STAFF REPORT

SUBJECT: Matador Estates

H-2022-0043

Annexation of 5.09 acres of land with an R-4 zoning district; and preliminary plat consisting of 14 building lots and two (2) common lots on 4.84 acres of land in the R-4 zoning district for Matador Estates Subdivision.

B. Preliminary Plat (dated: 5/12/22)

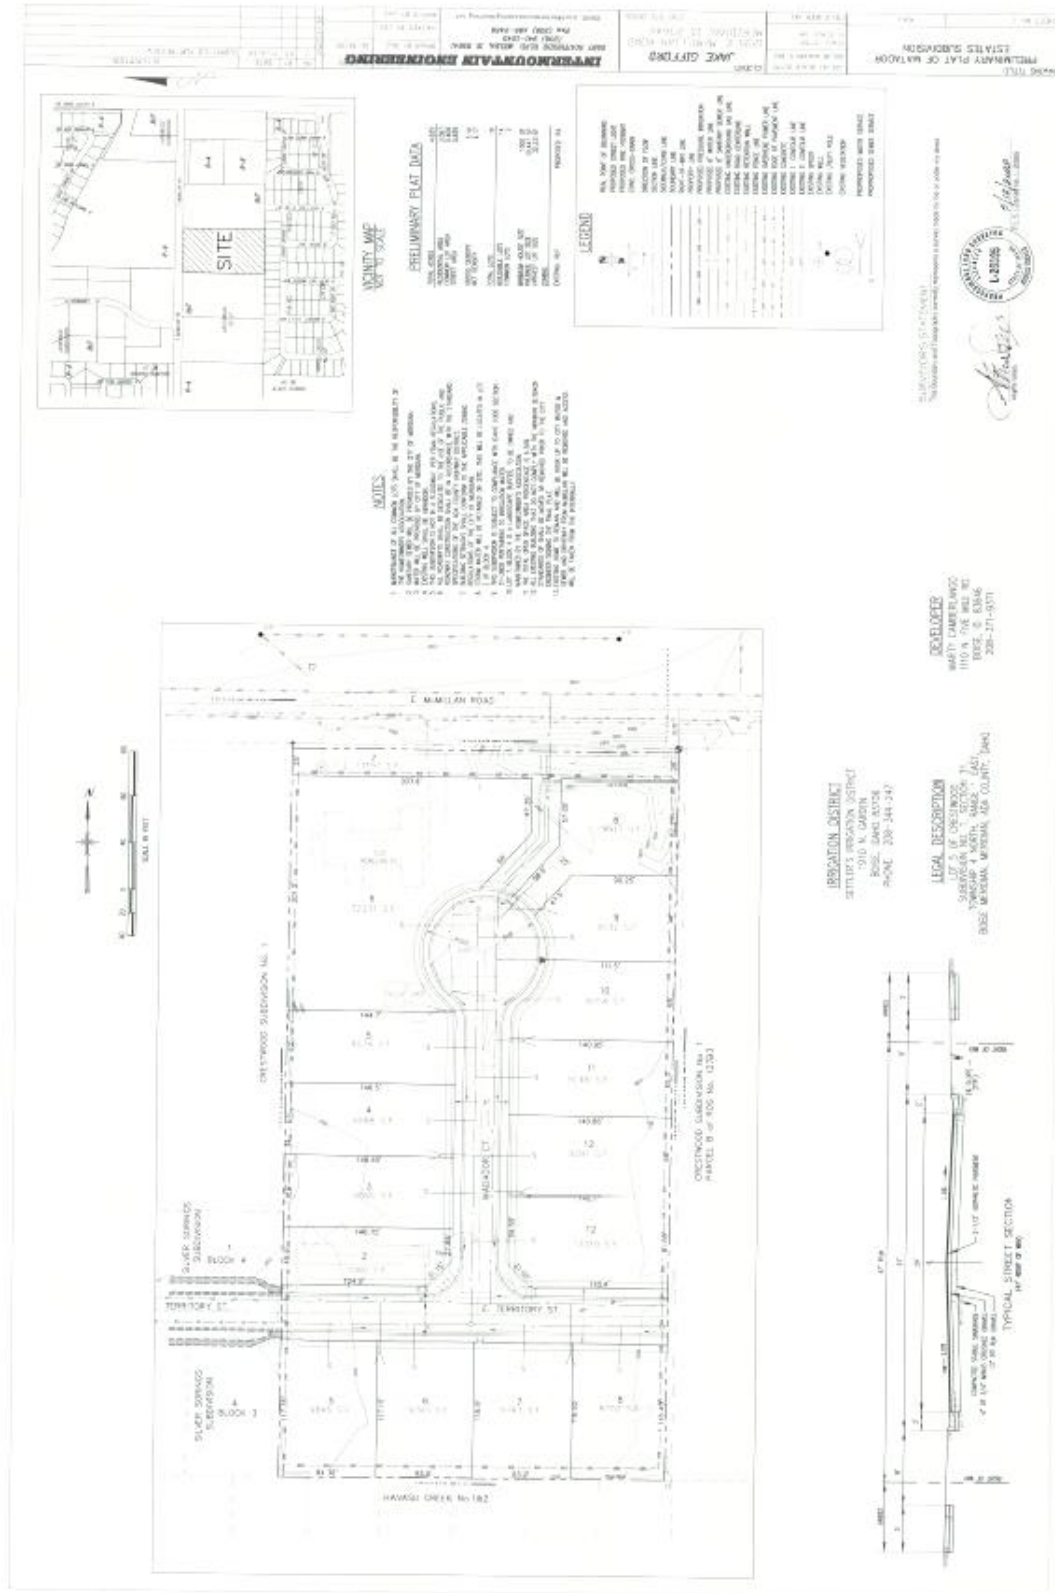
Dimensional Standards (UDC 11-2): The proposed plat and subsequent development is required to comply with the dimensional standards listed in UDC [11-2A-3](#) and [Table 11-2A-5](#) for the R-4 zoning district. **The proposed plat appears to comply with the dimensional standards of the district, except for the street frontage of Lot 8, Block 4 which should be a minimum of 30 feet; the plans should be revised accordingly.**

Landscaping is required along all pathways per the standards listed in UDC [11-3B-12C](#); **the landscape plan should be revised to include shrubs, along with the proposed trees and vegetative groundcover along the pathway on Lot 7, Block 4. A minimum of 5-feet should be provided outside of the easement area for trees; widen the lot if necessary to accomplish this.**

Common Open Space & Site Amenities (UDC 11-3G-3): Common open space and site amenities are required to be provided with development for properties of 5 acres or more in area per the standards listed in UDC [11-3G-3](#). **This site consists of 4.84 acres of land – the annexation boundary is 5.09 acres. Although not required by the UDC, Staff recommends as a provision of annexation in the DA that a minimum of 12% (or 0.58 acre) common open space is provided with development.** The landscape plan depicts 21,218.87 s.f. (or 0.49 acre) of common open space consisting of a 7,080 s.f. common area lot (Lot 2, Block 4), 2,840.74 s.f. of linear open space with a pathway (Lot 7, Block 4), and 50% of the street buffer along McMillan Rd. consisting of 4,178.13 s.f. **The plans should be revised to include an additional 0.09 acre of qualified common open space. If 8-foot wide parkways**

2. The final plat shall include the following revisions:
 - a. The minimum street frontage of Lot 8, Block 4 shall be a minimum of 30 feet as set forth in UDC [11-2A-3](#) and [Table 11-2A-5](#) for the R-4 zoning district.

- b. Graphically depict a 20-foot wide easement for the City of Meridian water main line on Lot 7, Block 4. Also, include a note with the recorded instrument number of the easement; a separate easement will be required.

- c. Provide a minimum 5-foot wide strip of land outside of the water main line easement noted above for landscaping along the pathway on Lot 7, Block 4.

- d. Correct the spelling of Matador Ct. (if spelled wrong).
3. The landscape plan submitted with the final plat shall include the following revisions:
